## Product Change Notice (PCN)

**PCN Number:** PCN-0450216R-01

**Product(s) Affected:** MD-SV series (part numbers MD-30SV, MD-40SV, MD-50SV, MD-60SV, MD-70SV, MD-80SV).

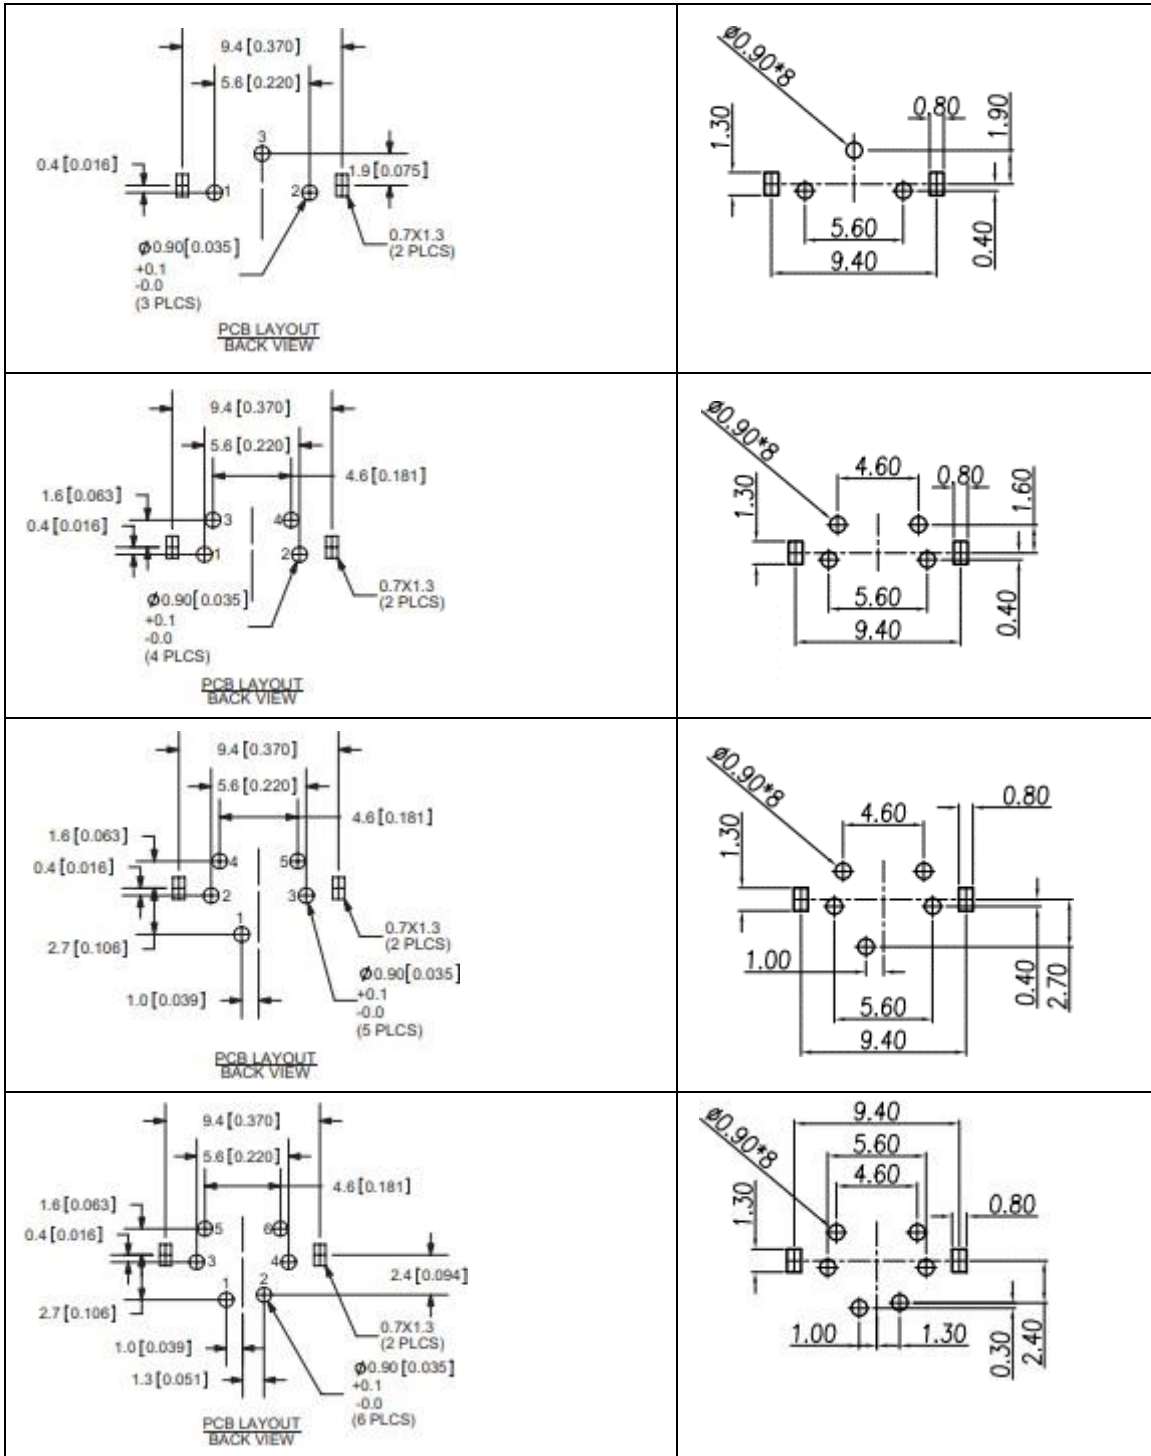
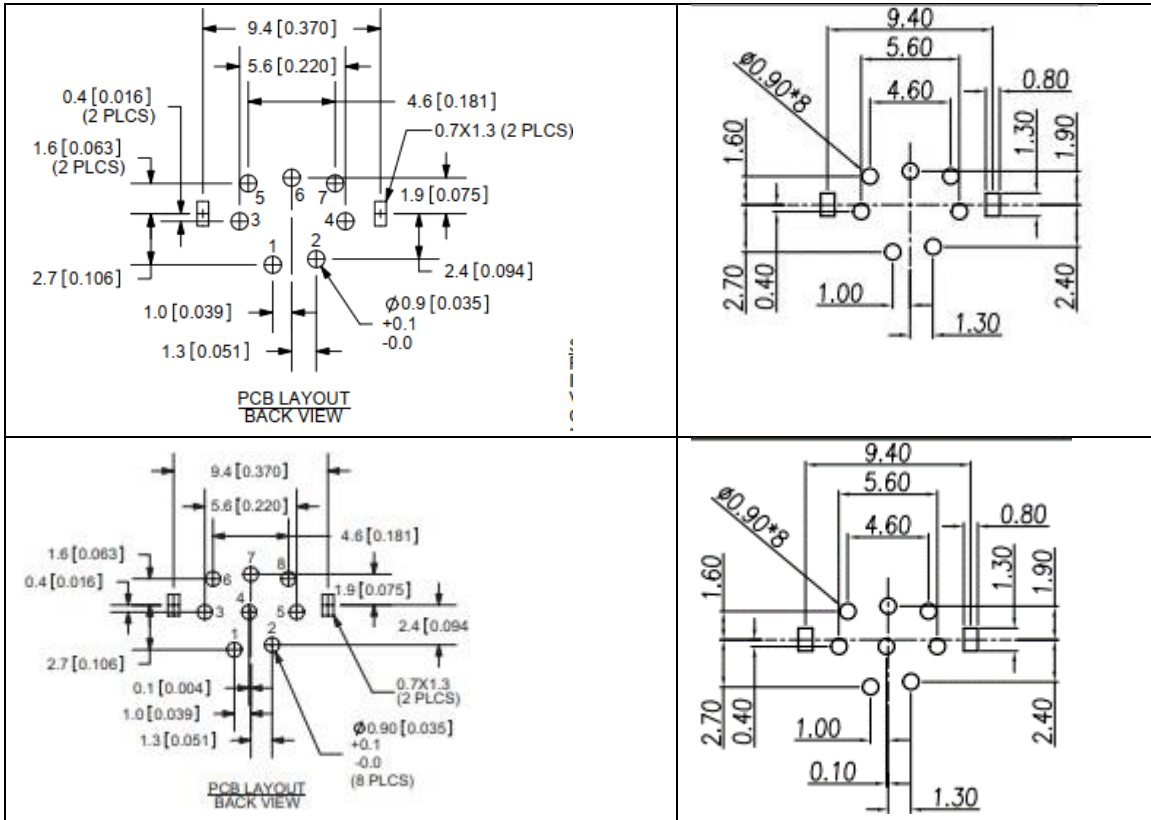
**Reason(s) for Change:** Manufacturing build location change.

**Description of Change:** minor dimensional changes, such as pin length, and materials changes as shown below.

MATERIAL	PLATING
earth terminal	brass	tin
contact terminals (1~8)	phosphor bronze	silver
plastic	PBT

MATERIAL	PLATING/COLOR
housing	PBT (UL94V-0)	black
contacts	phosphor bronze	tin
shell	brass	nickel
